*Board of Supervisors
City and County of San Francisco*

Government Audit and Oversight Committee

April 18, 2018 ♦ 10:00 a.m.

Tape Extensometers Data:

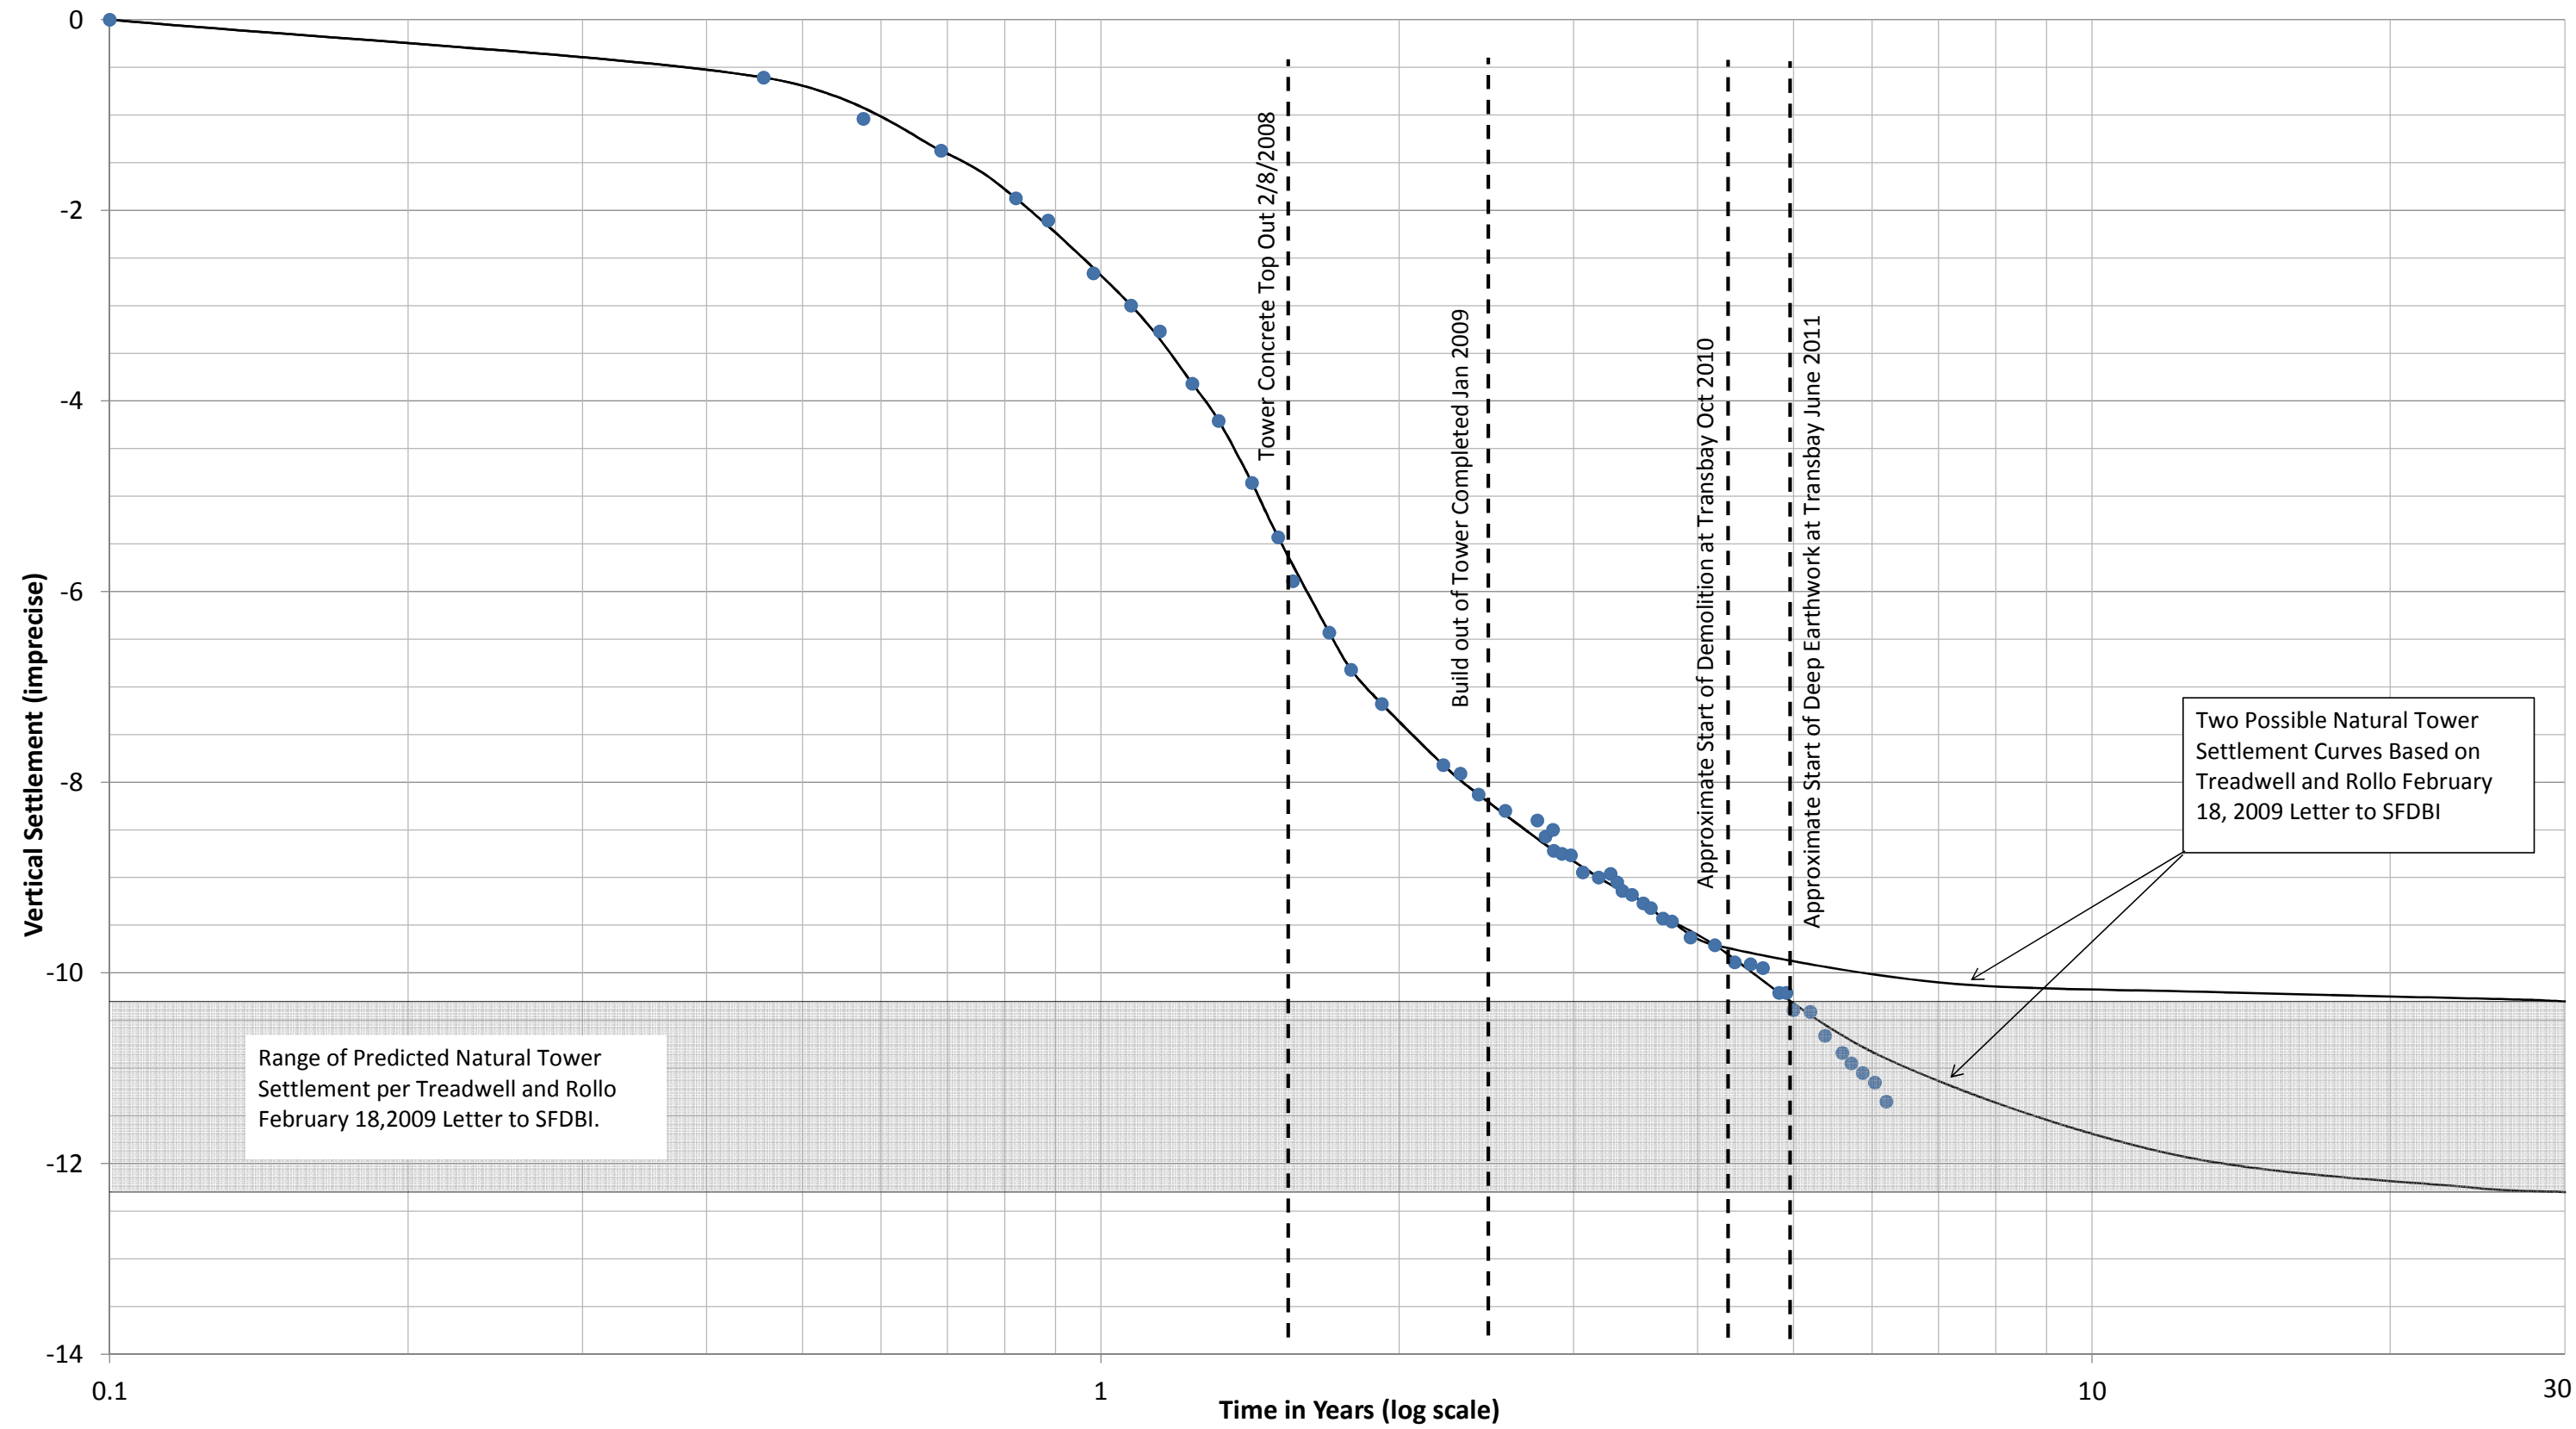
Tape extensometer data has been presented in the Arup report but was not uploaded on the Global Analyzer. All tape readings between May, 2009 and September 2012 are presented by Arup.

The tape extensometer data show a general trend of reduction in tape length along the gridline 12 wall. This type of measurement may be an indication about cracking, however, visual inspection is another good technique. The values of movement are less than a tenth of an inch. We will continue to monitor this movement and will plan a site visit soon.
